**Re: North American Electric Reliability Corporation
Docket No. RM__ - __ - __
Petition of the North American Electric Reliability Corporation for Approval of a
Revised Definition of “Bulk Electric System” in the NERC Glossary of Terms
Used in Reliability Standards**

**PETITION OF THE
NORTH AMERICAN ELECTRIC RELIABILITY CORPORATION
FOR APPROVAL OF A REVISED DEFINITION OF “BULK ELECTRIC SYSTEM”
IN THE NERC GLOSSARY OF TERMS USED IN RELIABILITY STANDARDS**

Principle 8:

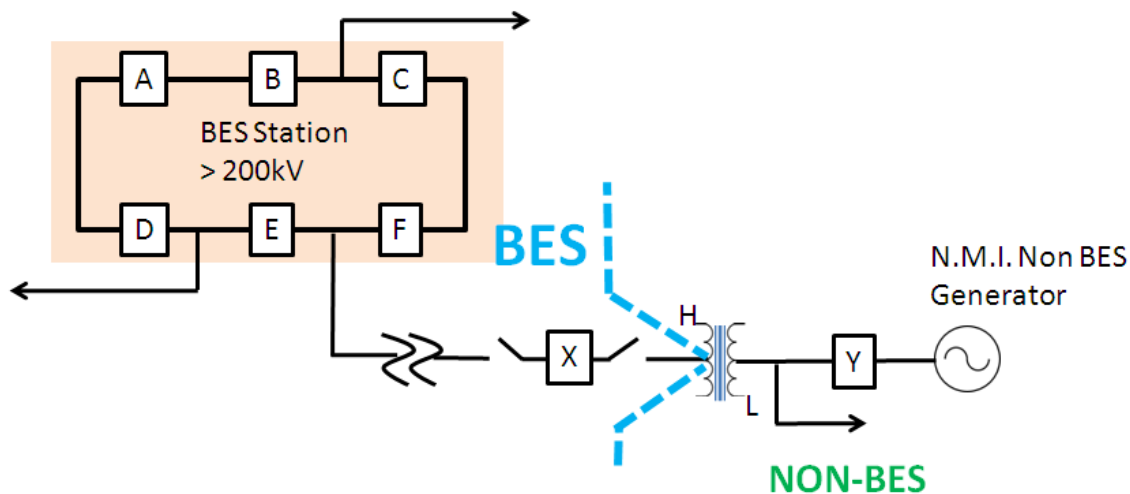
BDT - This diagram does not go with principle 8 and will be deleted from principle 8, but a principle 9 should probably be added to elaborate on the demarcation point between a non-BES generator and the BES.
